TOWN OF GLASTONBURY
GL-2015-18
Transfer Station Electrical Service Upgrade

ADDENDUM NO. 1
12/18/14

REVISED SECTION 16400 – SERVICE AND DISTRIBUTION

TITLE
ELECTRICAL SITE PLAN, DETAILS, AND SCHEDULES

E-1

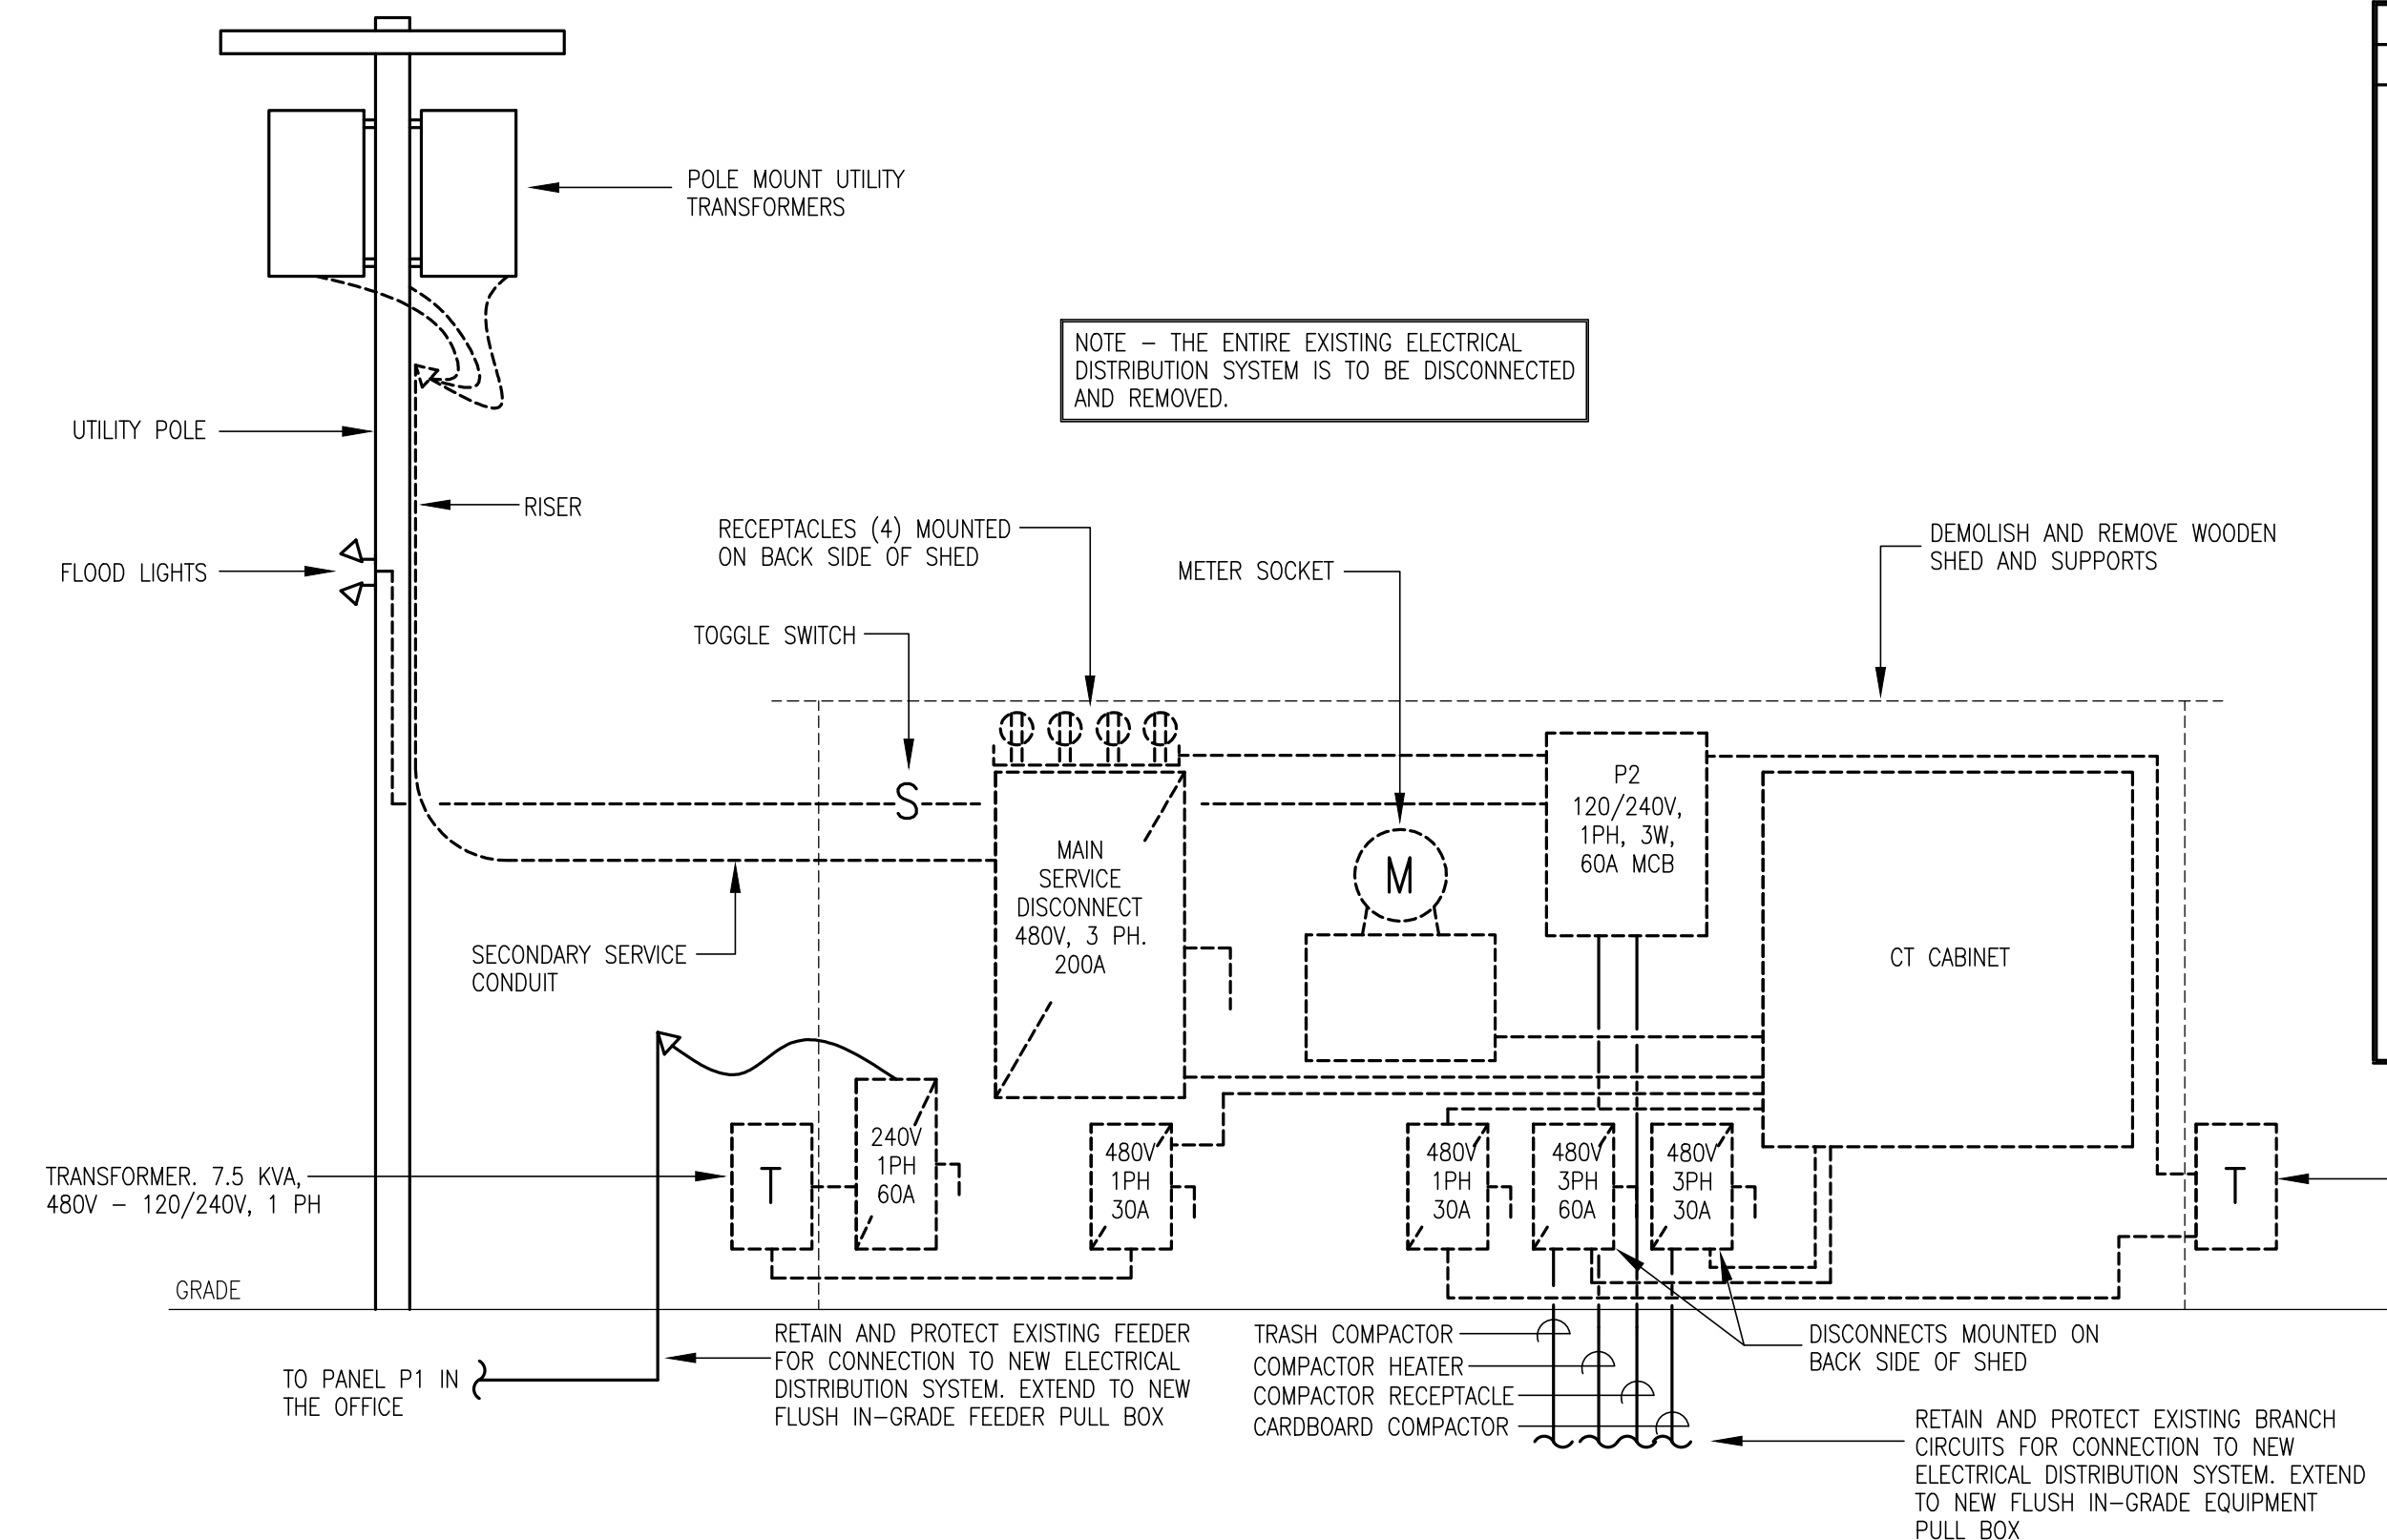
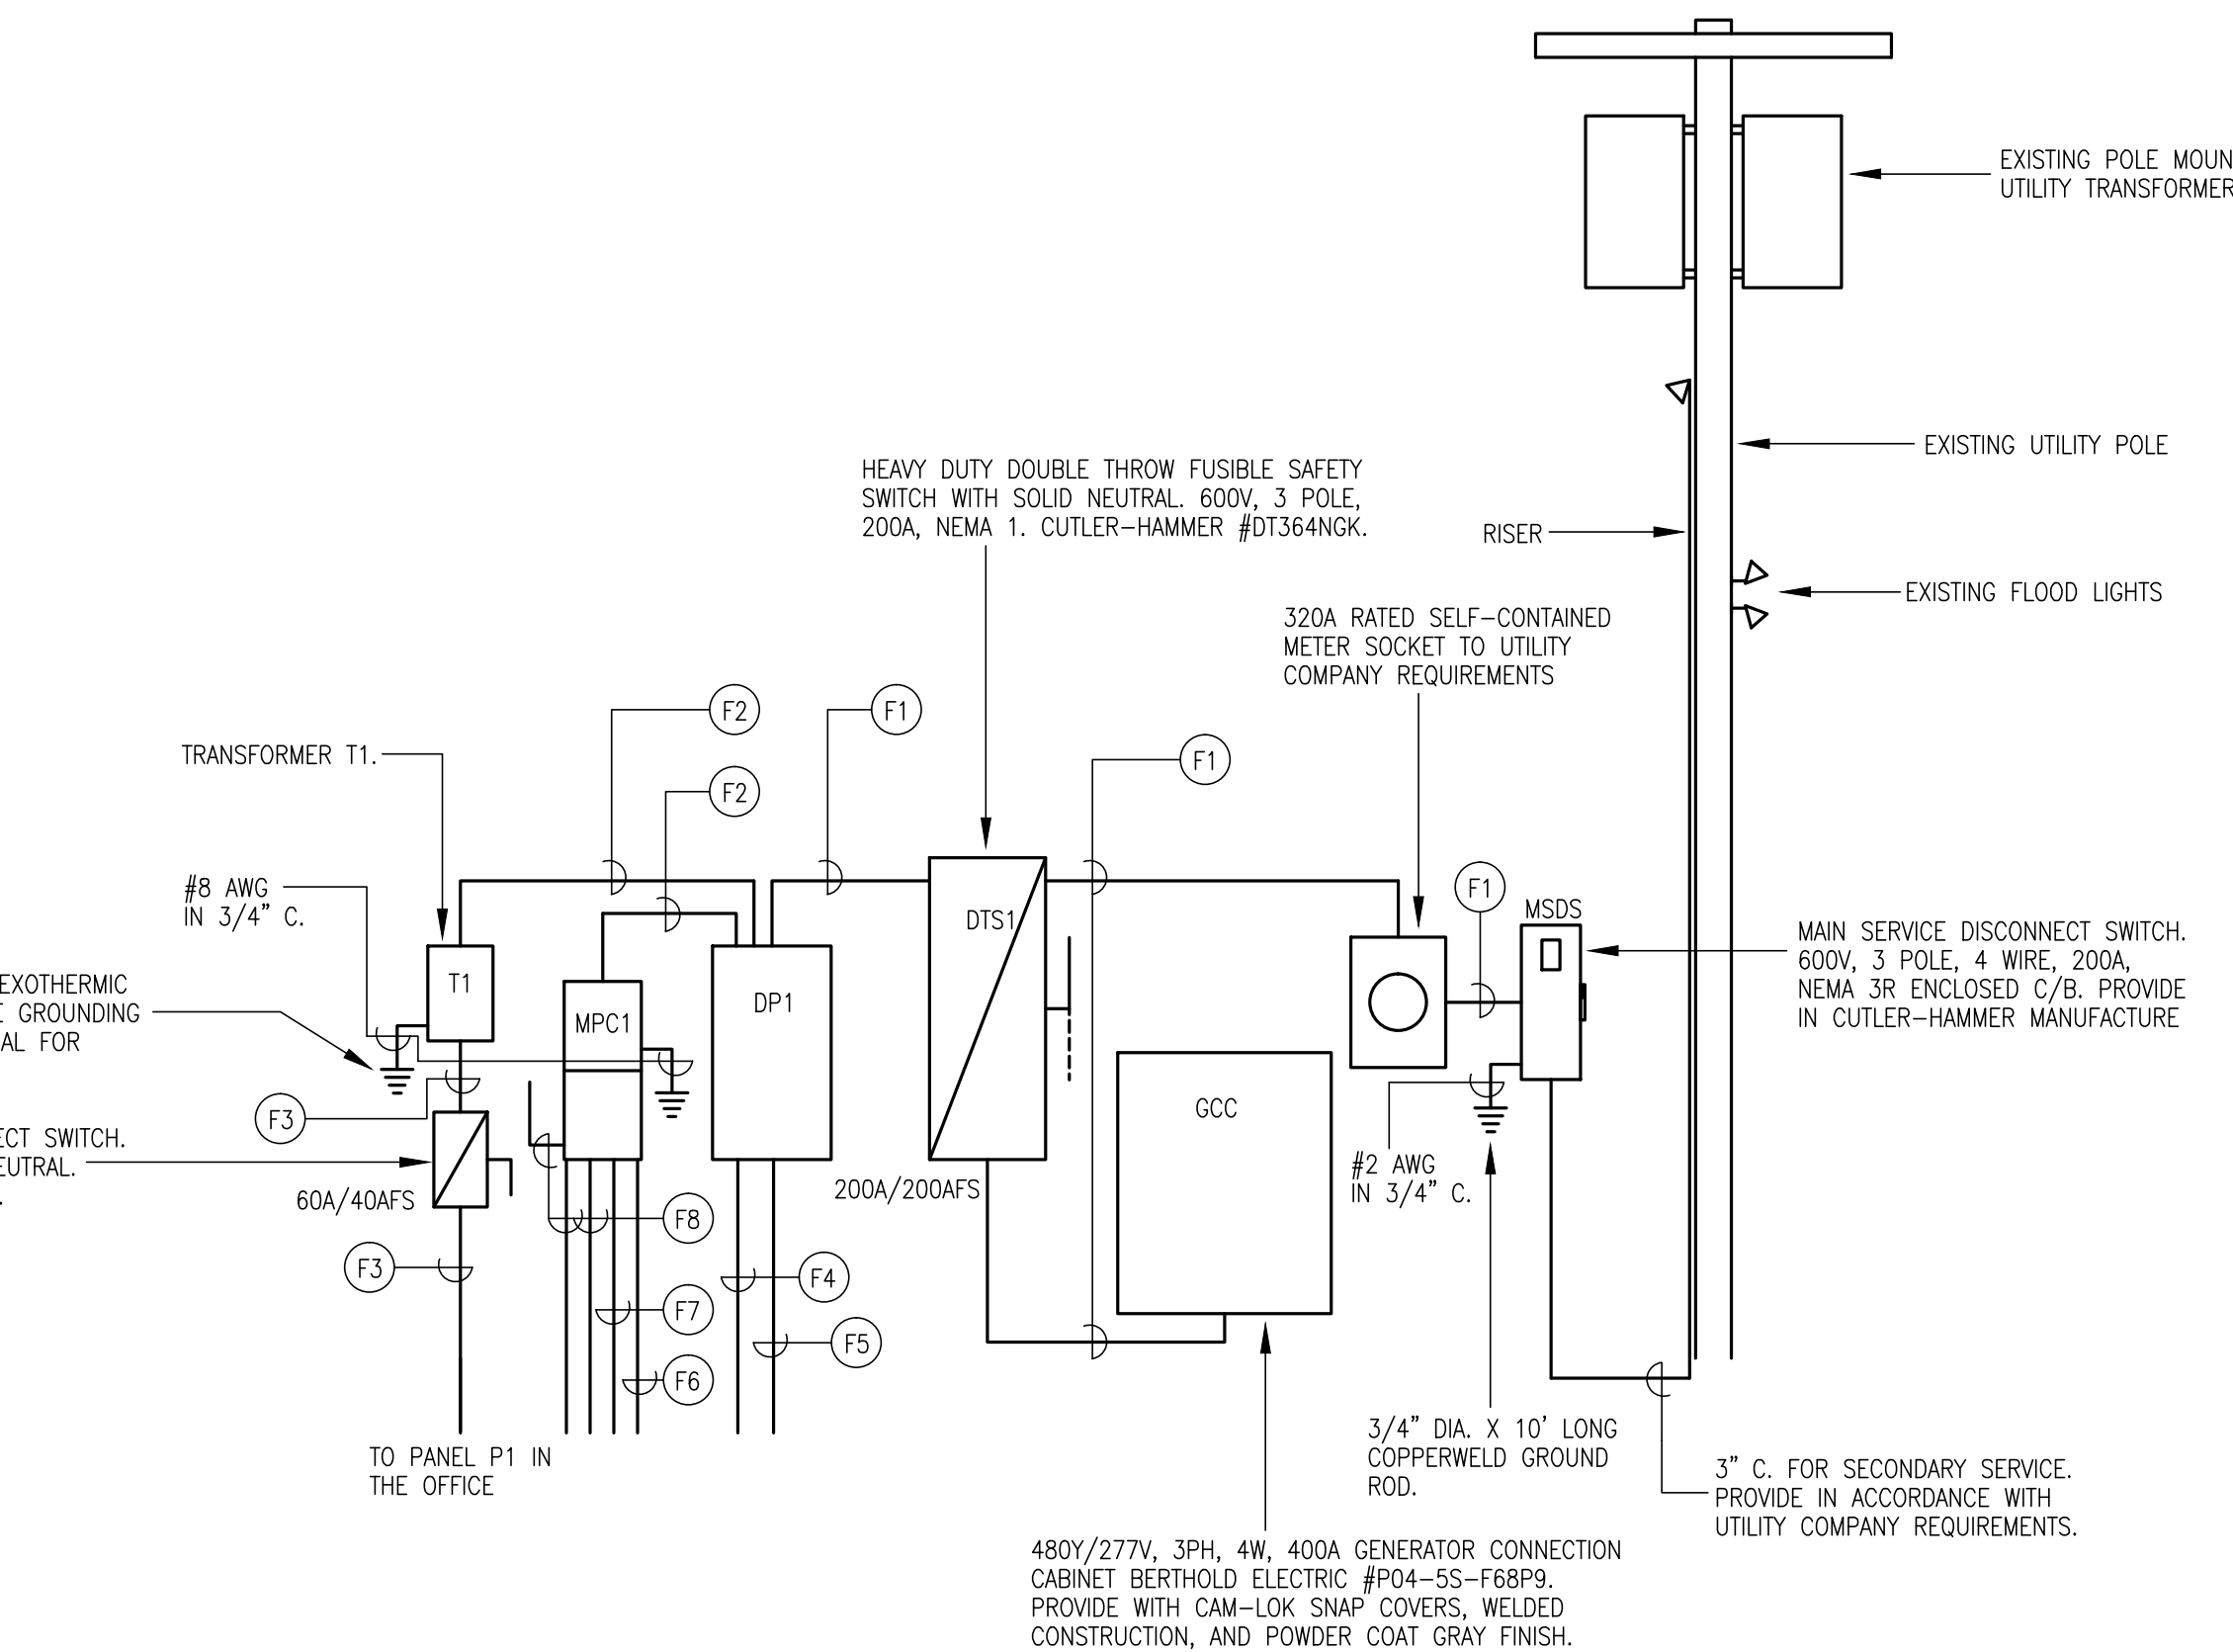
- **Replace:** Specification Section 16400 with the attached **REVISED** Section 16400 in its entirety.
- **Replace:** Drawing E-1 with the attached **REVISED** Drawing E-1

REVISIONS
 ADDENDUM #1 - ELECTRIC SERVICE AND DISTRIBUTION REVISIONS.
 12/18/14 - ADDENDUM ELECTRIC SERVICE AND DISTRIBUTION REVISIONS.
